Document 00 20 00 - Addendum No. 1

DATE: November 24, 2025

SUBJECT: ADDENDUM NO. 1 TO THE BIDDING DOCUMENTS FOR

SE878E Woodland Lodge - Woodland HVAC and Roof Replacement
Indiana University Southeast
IU 20251224

VPS ARCHITECTURE	Issue Date: 11/21/25	Project Title: MEADOW & WOODLAND LODGE - HVAC AND ROOF REPLACEMENT - DUCT PENETRATION
Client Project No:	Referencing Drawing No:	Drawing No: ADD1-ASK1

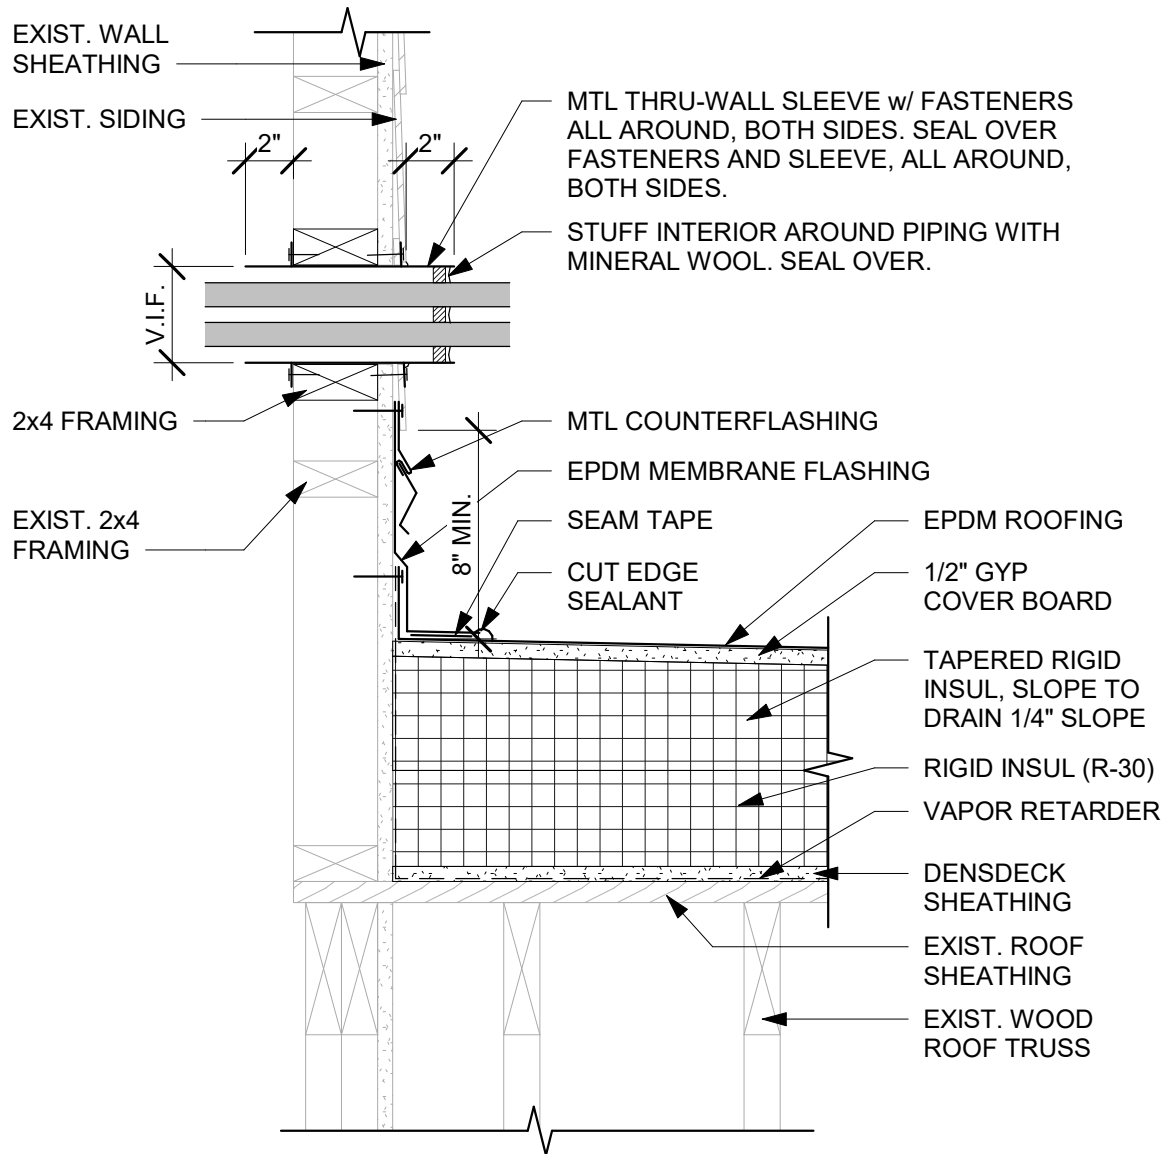
2. Sheet A001 – GENERAL PROJECT INFORMATION:
 - a. Added “DUCT PENETRATION” detail as indicated on attached sketch, ADD1-ASK1.
 - b. Added “PIPE PENETRATION” detail as indicated on attached sketch, ADD1-ASK2.

VICINITY MAP

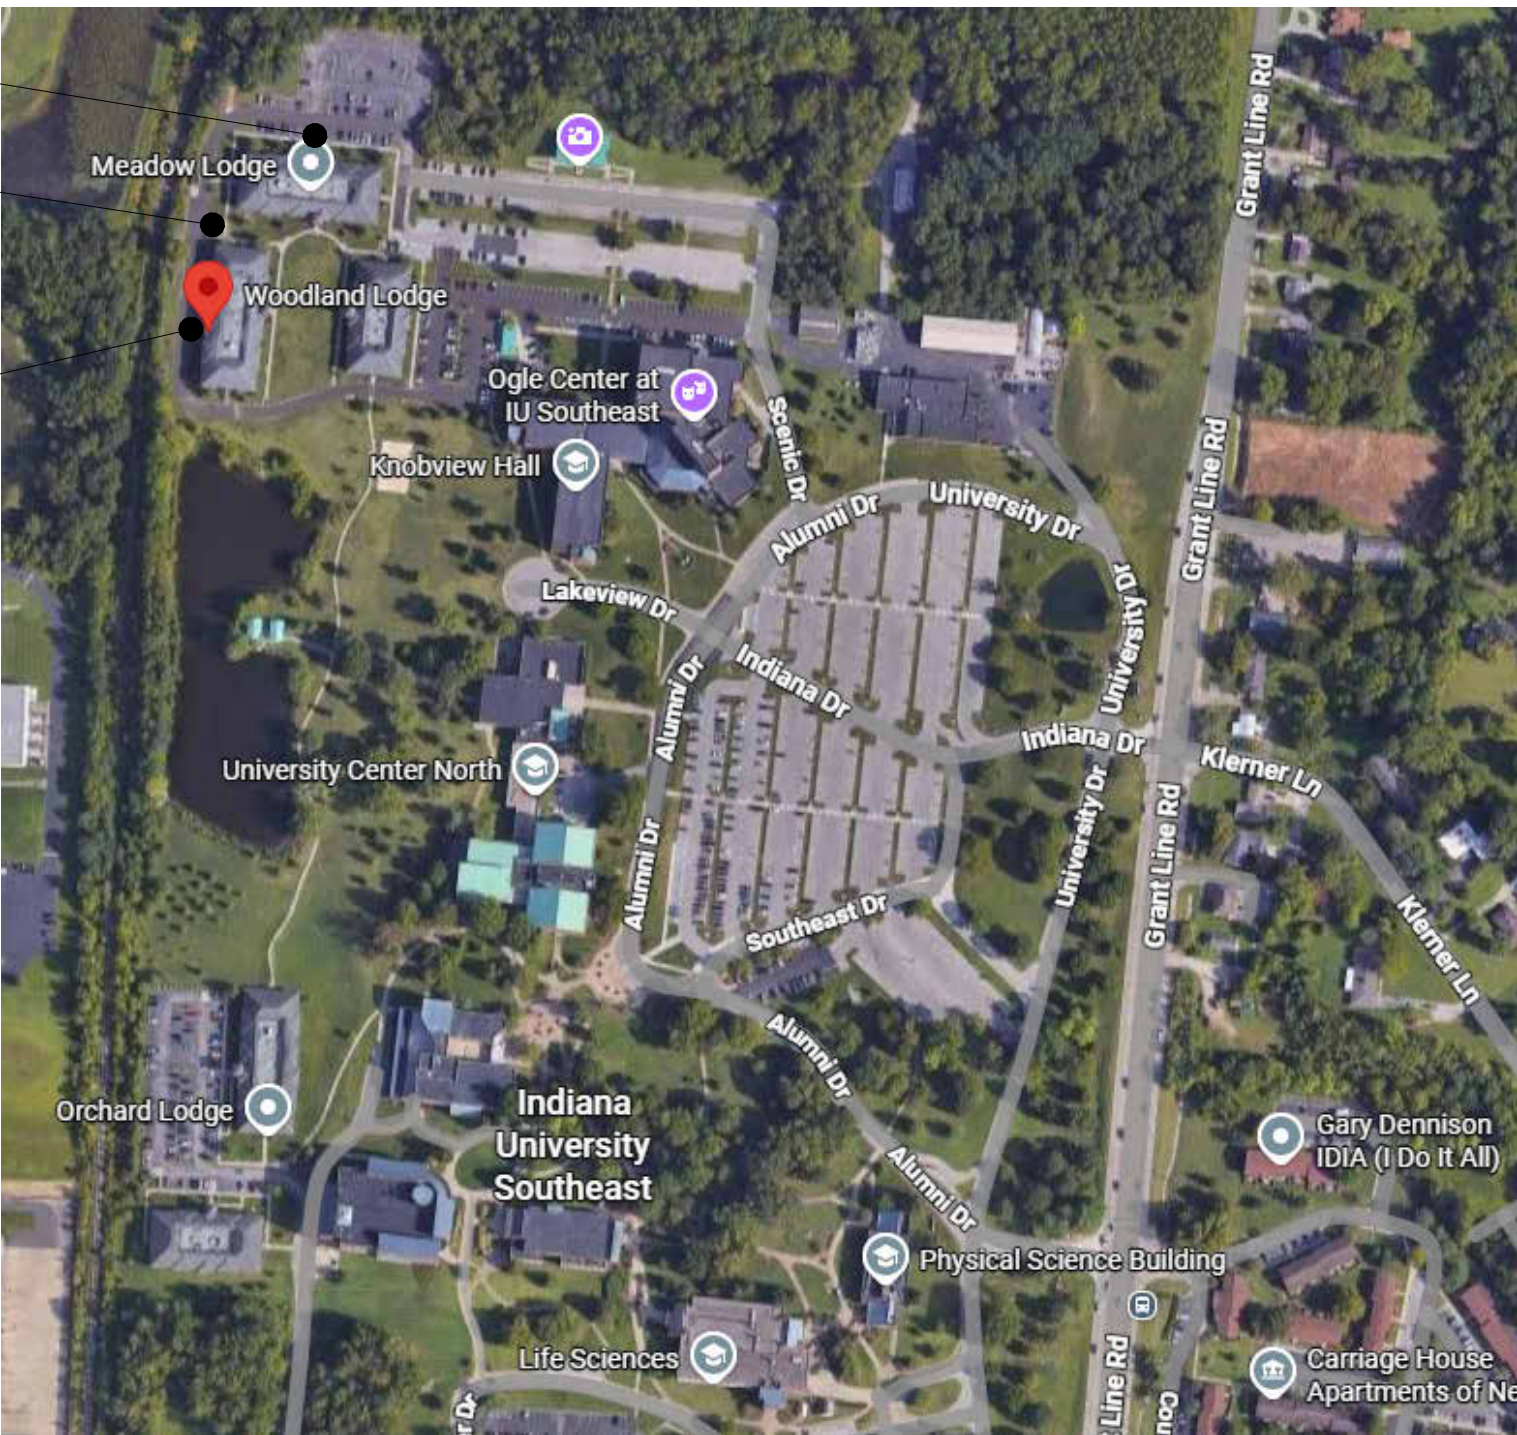
1. Sheet G001 – COVER SHEET:
 - a. Updated “VICINITY MAP” to show proposed crane locations and note as indicated on the attached.
 - b. Updated “PROJECT PHASING” as indicated on the attached.

PROPOSED CRANE LOCATION (MEADOW LODGE)
PROPOSED CRANE LOCATION (BOTH LODGES)
PROPOSED CRANE LOCATION (WOODLAND LODGE)

NOTE: CRANE SHALL STAY ON ASPHALT. CONTRACTOR SHALL PROTECT ALL SURFACES FROM CRANE. CONTRACTOR SHALL ASSUME RESPONSIBILITY FOR ANY DAMAGE RELATED TO THE LOADING/UNLOADING, MOVING, AND/OR OPERATION OF THE CRANE AND ITS OUTRIGGERS.

MD101

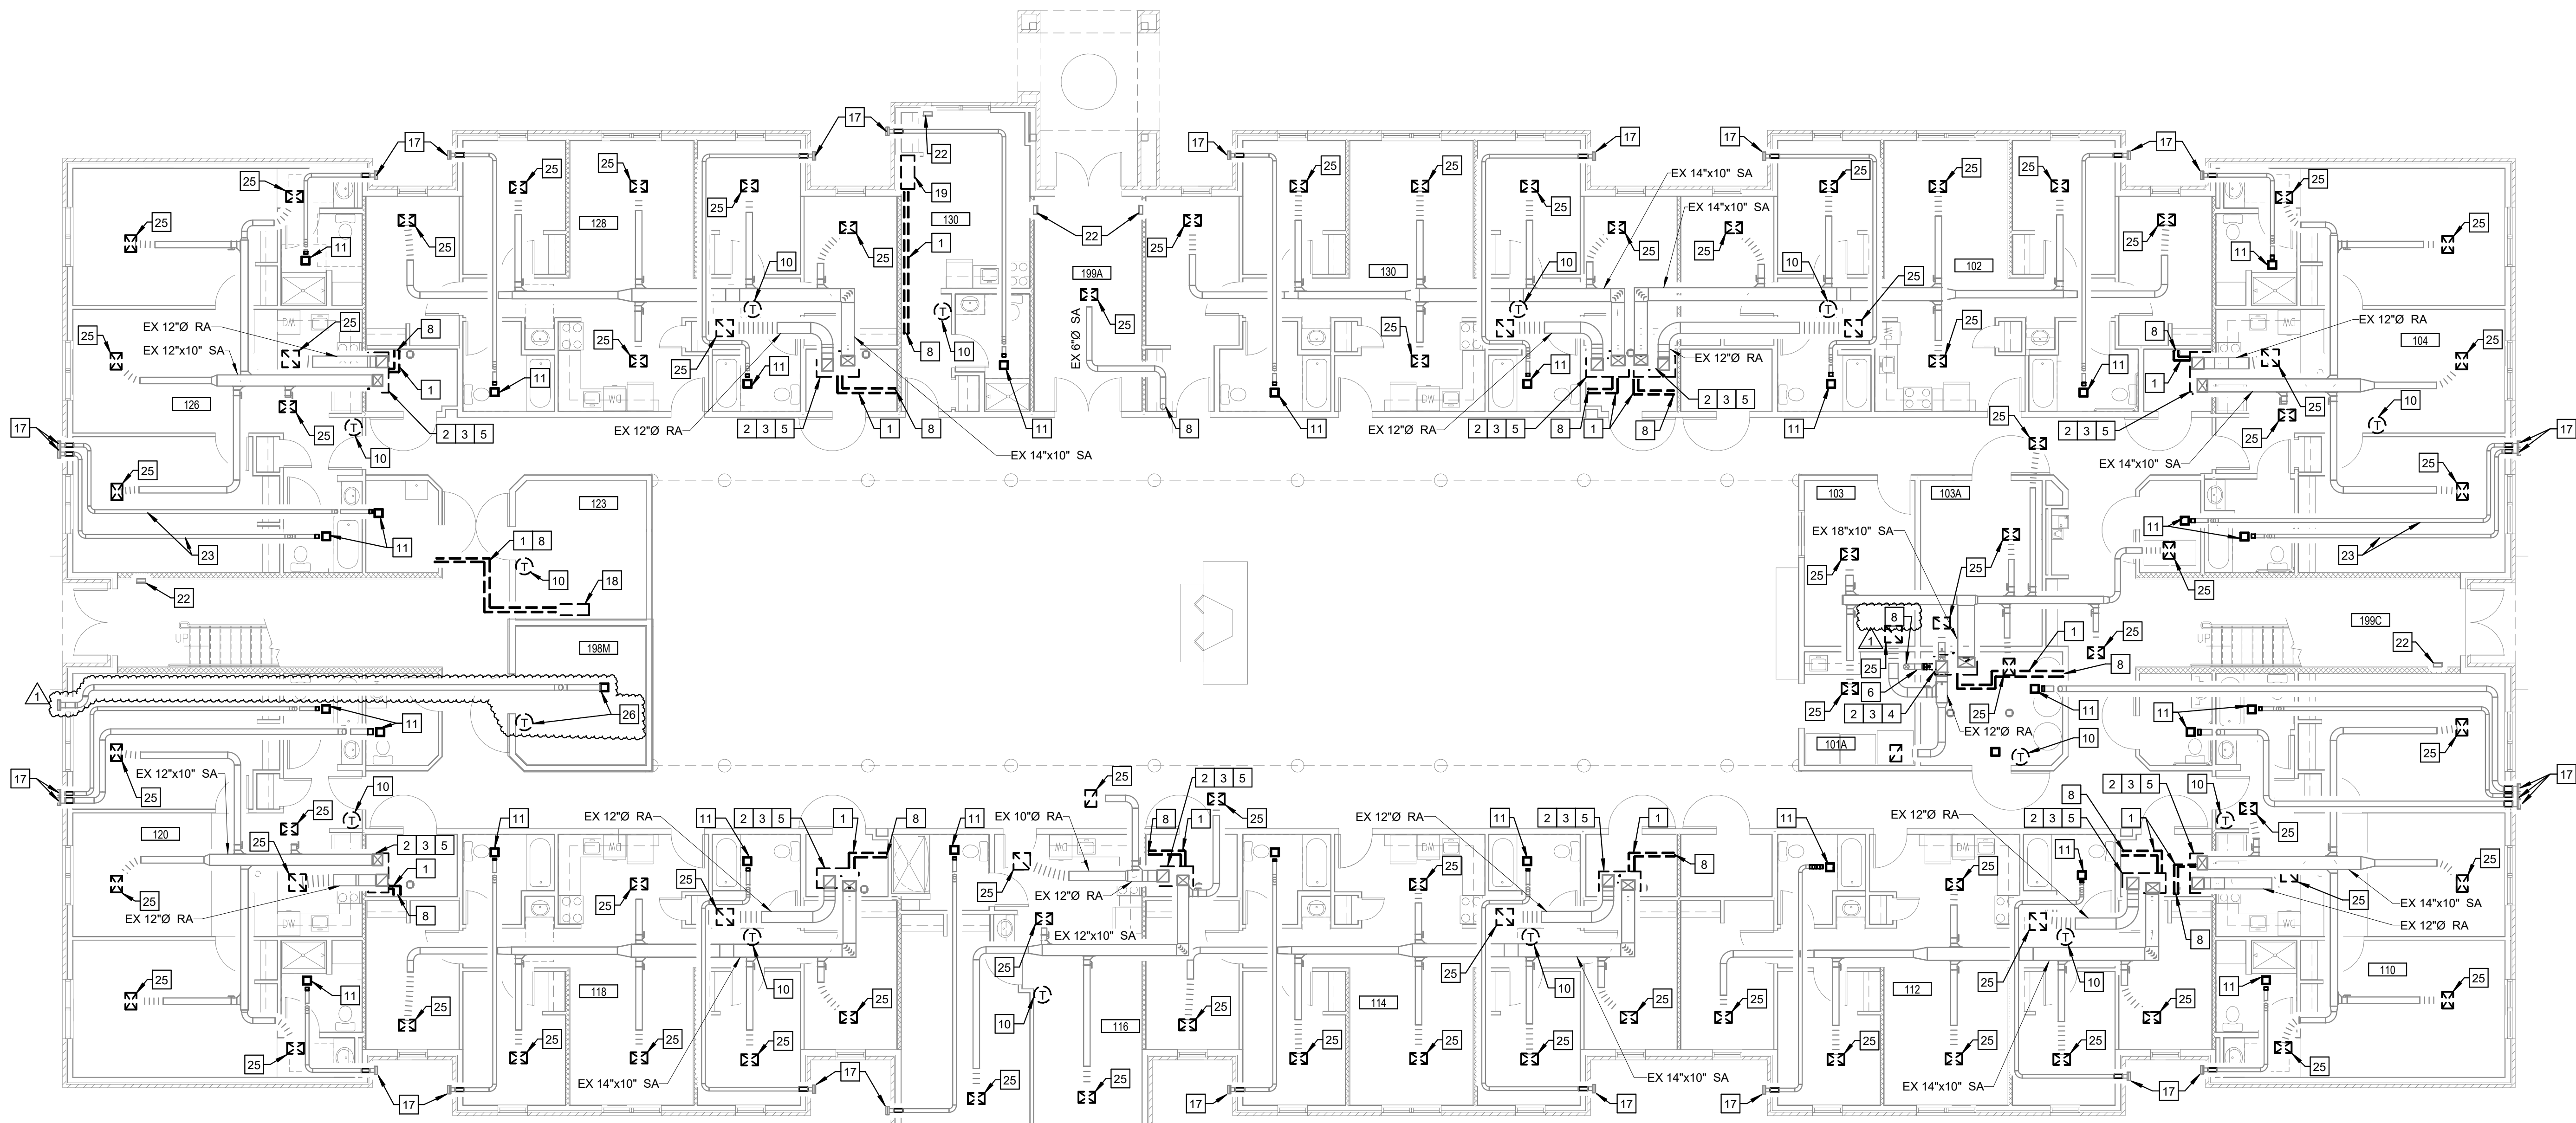
3. Sheet MD101 – MECHANICAL DEMOLITION PLANS:
 - a. Added Keyed Note 26 as indicated on the attached.
 - b. Modified Keyed Notes in room Electrical Room 198M as indicated on the attached.

- c. In room 103, Keyed Note 13 was deleted as indicated on the attached.
 - d. Modified Keyed Note 10 as indicated on the attached.
4. Sheet M101 – MECHANICAL PLANS:

M101

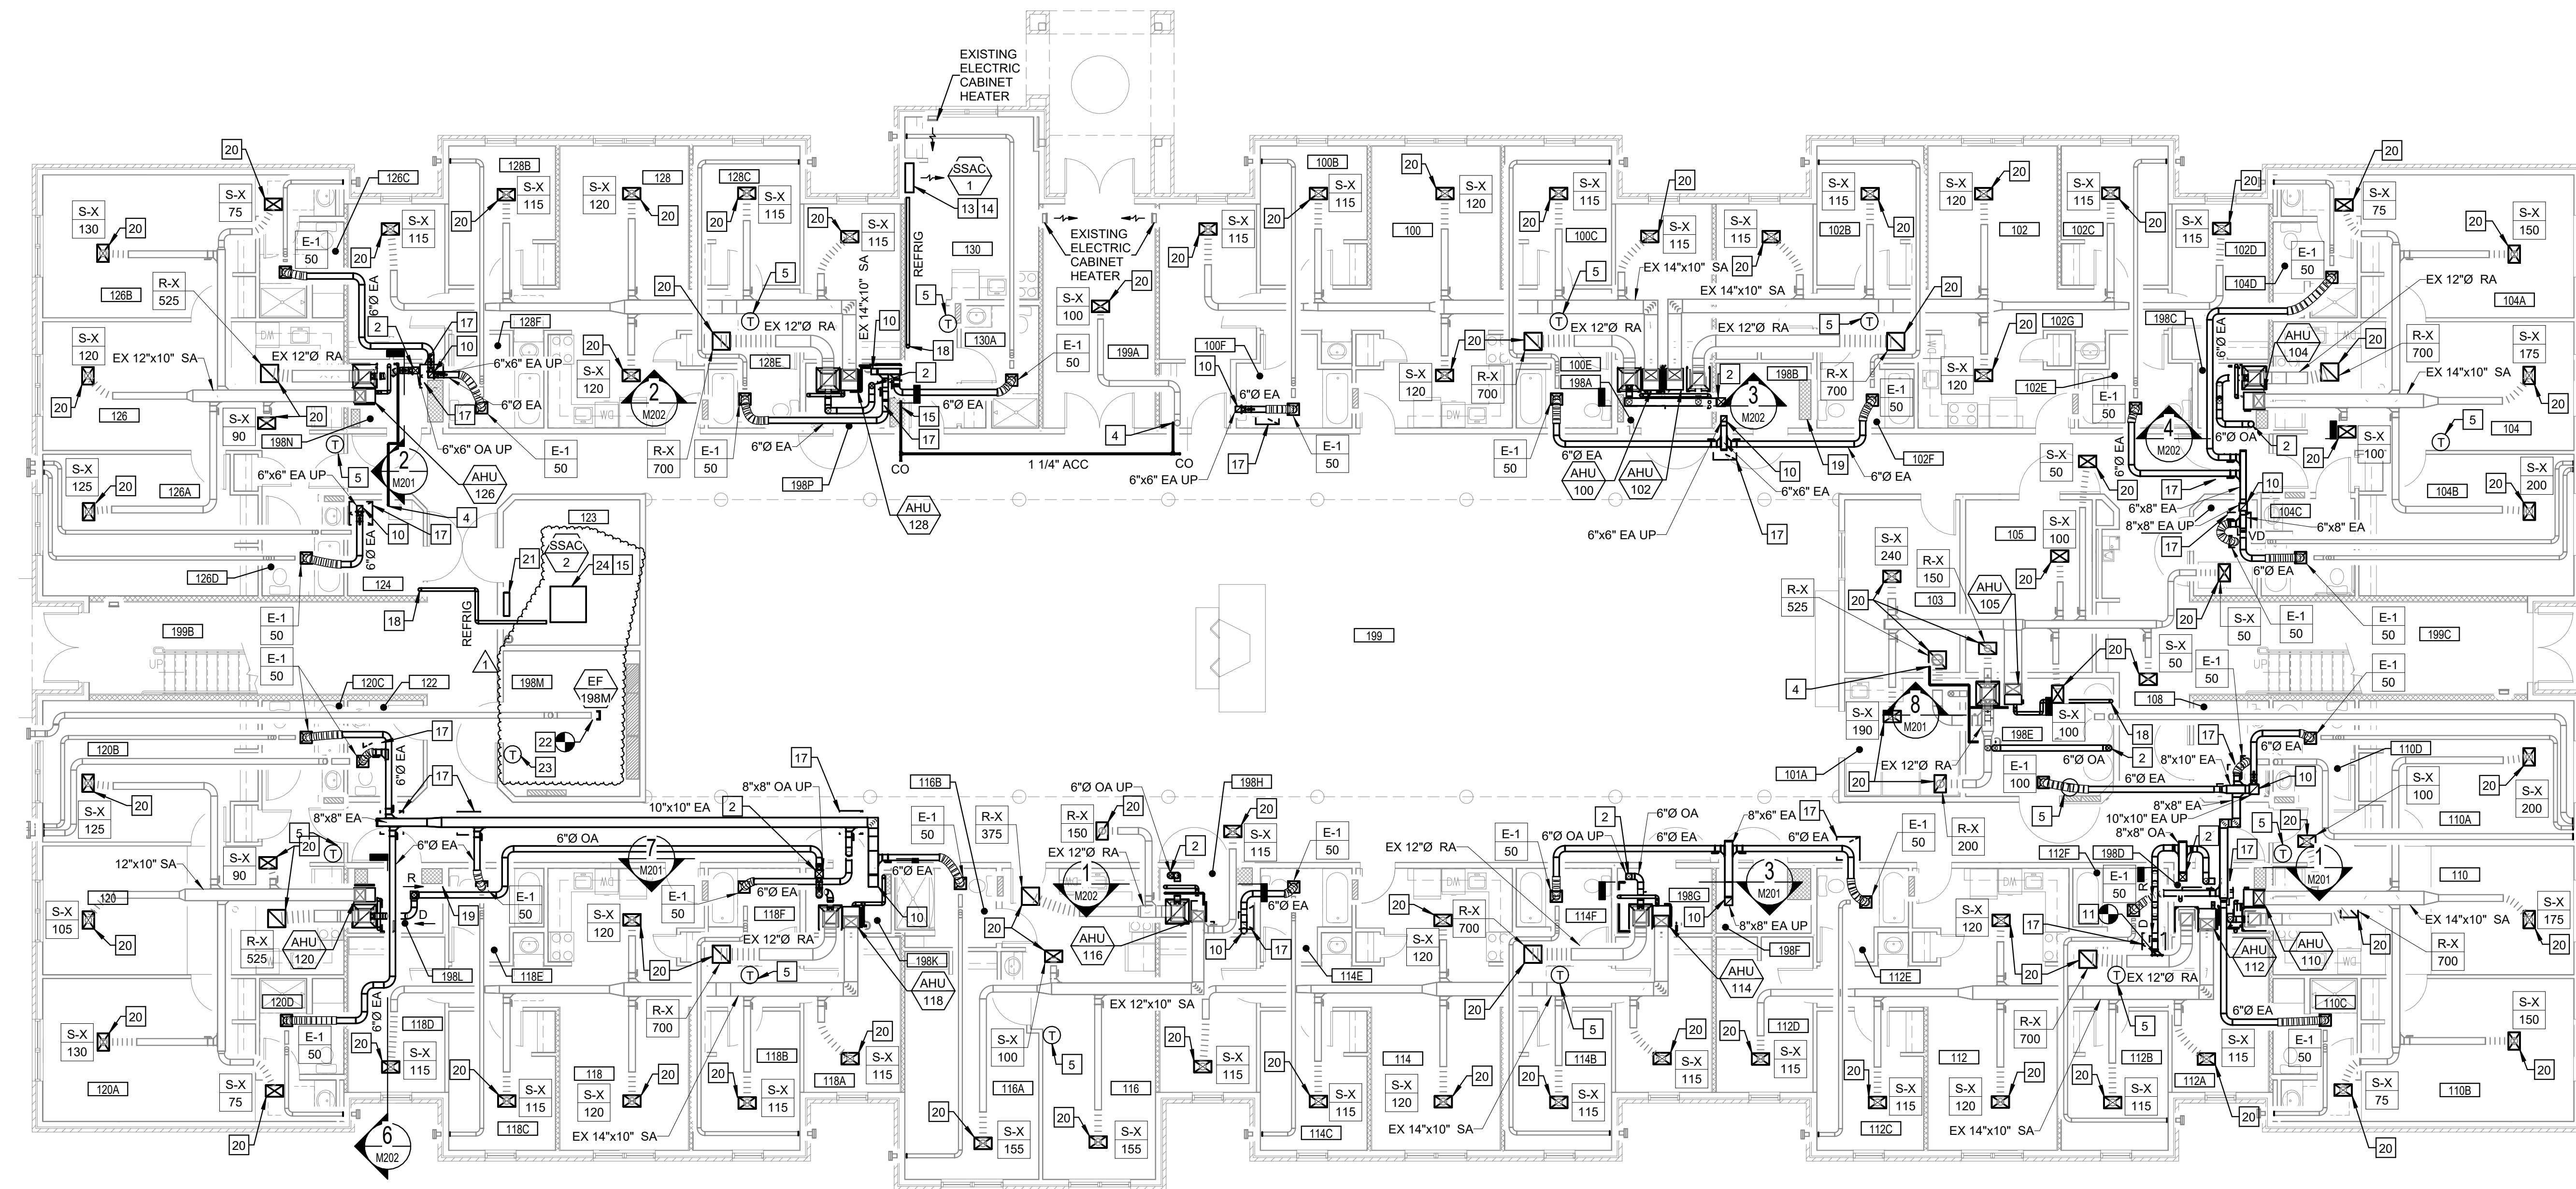
- a. Added Keyed Notes 22, 23, and 24 as indicated on the attached.
 - b. Replaced new exhaust grille and associated branch duct in Electrical Room 198M with new exhaust fan, EF-198M as indicated on the attached.

- c. Connected new EF-198M to existing exhaust air duct as indicated on the attached.
 - d. Modified Keyed Notes in room Electrical Room 198M as indicated on the attached.

- e. Modified Keyed Note 5 as indicated on the attached.
5. Sheet M401 – MECHANICAL SCHEDULES:
 - a. Updated “SPLIT SYSTEM SCHEDULE” as indicated on the attached.
